**RAPID CITY**  
**BUILDING INSPECTION**  
 Reviewed by CB  
 Date 8-30-04

REVIEWED PLANS

04PD056

REAR ELEVATION

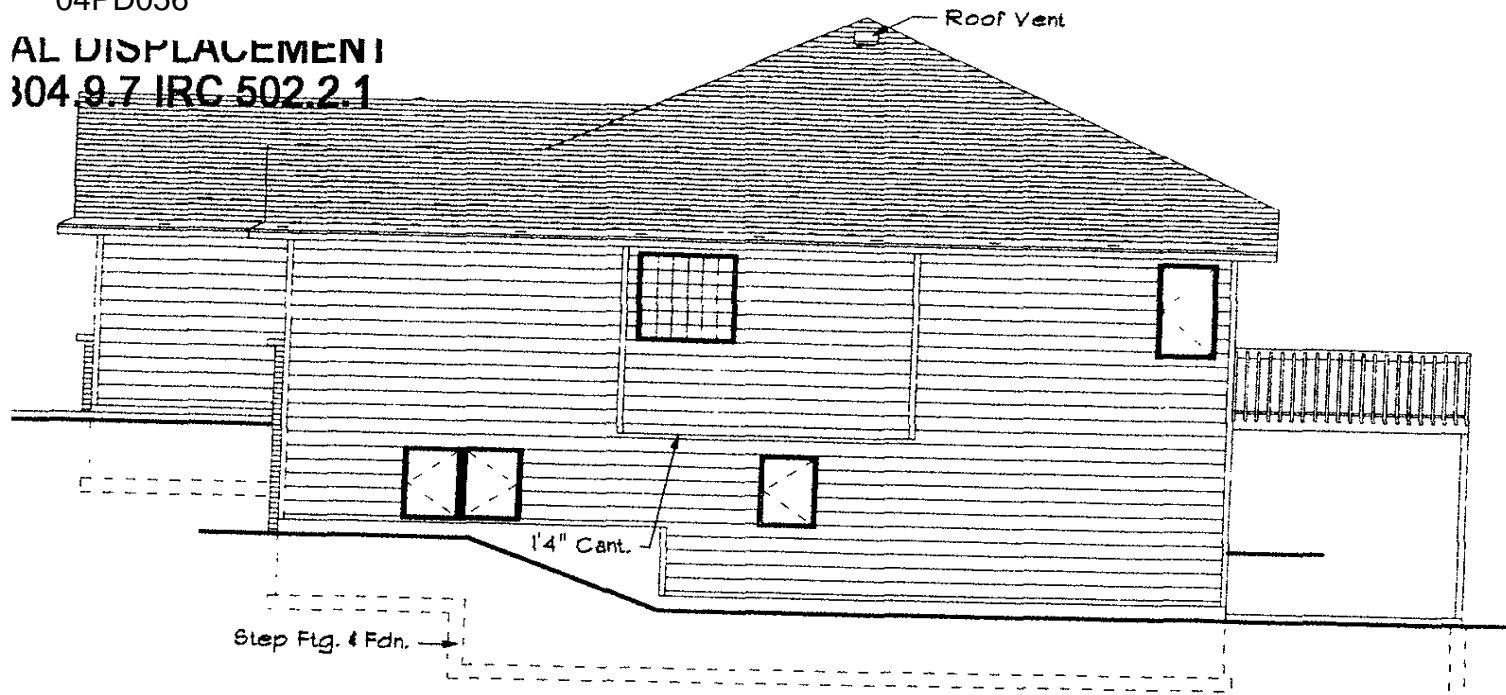
PROVIDE POSITIVE CONNECTIONS TO ENSURE AGAINST UPLIFT AND LATERAL DISPLACEMENT

IBC 2304
